November 11, 2024

Re: **Citizen on Constitution Filing No. 1 - Detention Pond Certification Letter  
El Paso County, Colorado**

# DETENTION BASIN STAGE-STORAGE TABLE BUILDER

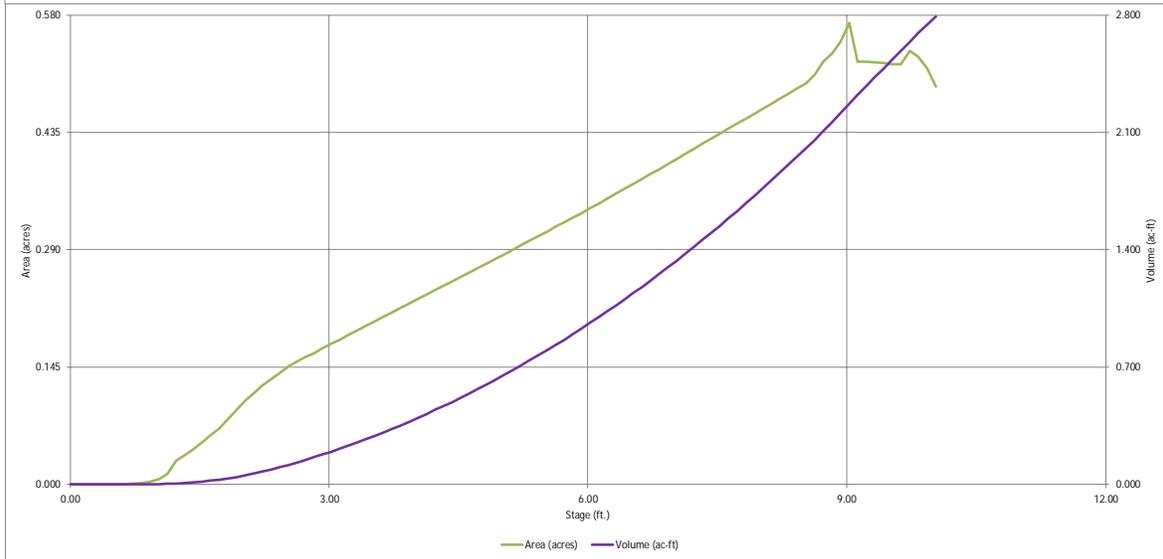
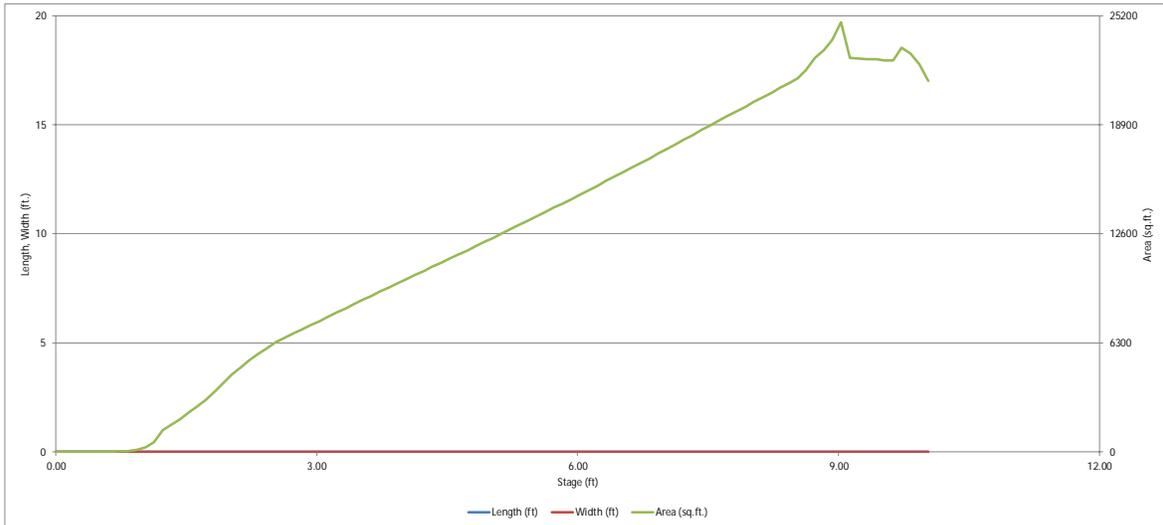
So reference that the updated MHFD calcs have been attached to this letter and why they were needed (ie: some of the inputs changed due to as-built conditions)

Please highlight/circle the inputs that were updated to show as-built conditions as I have done below.
